Subject: 9/1-2/09 BOARD MEETING (Item 10: General NPDES Permit for Discharges of Stormwater Associated with Construction Activities (CGP))
FSI 077026.3
Delivered via email

Flow Science Incorporated (Flow Science) respectfully submits these comments on the addendum (Staff Change Sheet #1, dated August 17, 2009) to the Draft General NPDES Permit for Discharges of Stormwater Associated with Construction Activities (CGP) (dated April 22, 2009). On behalf of the California Building Industry Association (CBIA), the Construction Industry Coalition on Water Quality (CICWQ), and the Building Industry Legal Defense Foundation (BILD), Flow Science has previously contributed to comments submitted by the CBIA, including a detailed report entitled "General Construction Permit: Action Levels and Numeric Effluent Limits Analysis and Recommendation of Alternatives," dated June 24, 2009.

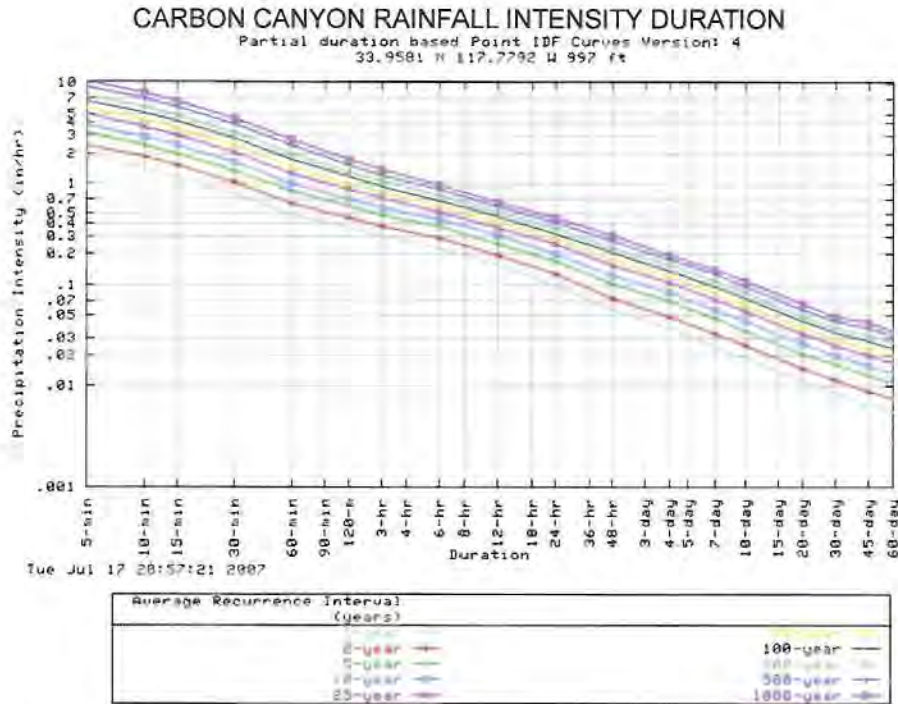
3. **Published, peer-reviewed studies and reports on in-situ performance of best management practices in terms of erosion and sediment control on active construction sites.** SWRCB Staff cite only one report (Horner, Guedry, and Kortenhof, 1990) and a comment letter from Dr. Horner to the State Water Board in support of the proposed NEL. The tests in Horner et al. (1990) were conducted in Washington State, and while a total of thirteen (13) storms were tested, the rainfall intensity for those storms varied from 0.009 to 0.119 inches/hour. Rainfall intensities higher than this are common in California, particularly in mountainous regions. For example, Wieczorek (1987)¹ observed rainfall intensities of up to 1 inch/hour in the La Honda area (Santa Cruz Mountains) in 1983. The California Stormwater BMP Handbook (January 2003, Appendix D) provides rainfall intensities for 19 locations throughout the State of California; the percent of time that a rainfall intensity of 0.1 in/hr is exceeded at these locations ranges from about 8% of the time (Bakersfield Airport, Palm Springs) to about 23% of the time (Oxnard, Santa Susana). An example rainfall intensity plot (for

Carbon Canyon, in Orange County) from NOAA² is shown below. This plot demonstrates that a one-hour rainfall intensity for a storm with a 1-year recurrence interval is about 0.5 in/hr in Carbon Canyon.
